# 1963 - 1964 Corvette: Service News: Air Conditioning Changes

**Subject:** Air Conditioning Changes  
**Model and Year:** 1963 - 1964 Corvette  
**Source:** Chevrolet Service News  
**Date:** March 1964 - Volume 36 - Number 3

*Fig. 1—Rework of Blower Motor Circuit*

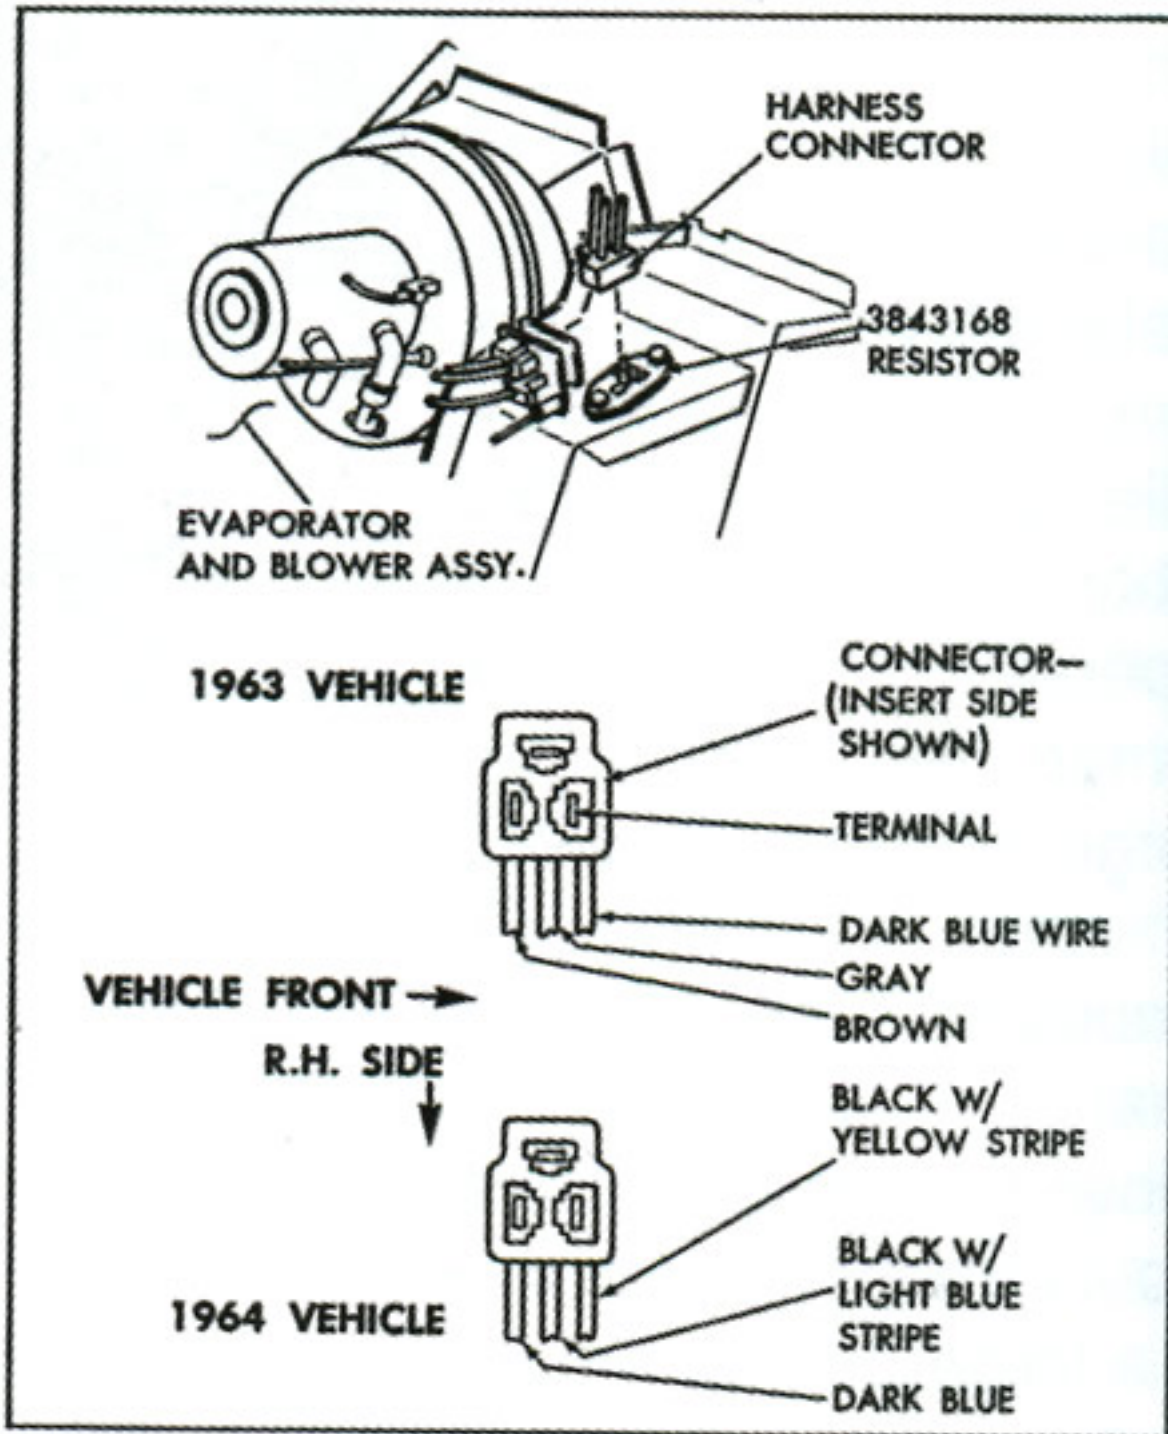
On all 1963 and early 1964 Corvettes equipped with Air Conditioner RPO C60, it would be necessary to slightly modify the electrical circuit to provide a true medium blower speed for the heater. In these RPO C60 installations, the resistor that was used in the blower motor circuit to establish blower medium and low speeds, unfortunately, during heater operation provides blower "low" RPM at the MEDIUM as well as at the LOW speed setting of the operator's control lever.

A wiring change introduced in Production averted the above problem on vehicles built later than December 16, 1963.

To provide the desired medium blower speed, on the earlier production units, proceed as follows:

1. Replace the installed blower motor resistor with Resistor Part No. 3843168.
2. Reverse the location of two leads in the multiple connector that plugs into the blower motor resistor assembly; reinstalling the color coded leads in the connector body at the locations show in Fig. 1.

NOTE: To remove the terminals from the connector body, insert a small screwdriver along the inboard side of the terminal and move the end of the screwdriver outboard to disengage the terminal from the locking ledge in the connector. Before reinstalling the terminals in the connector, spread the

terminals to insure that they lock securely when installed.
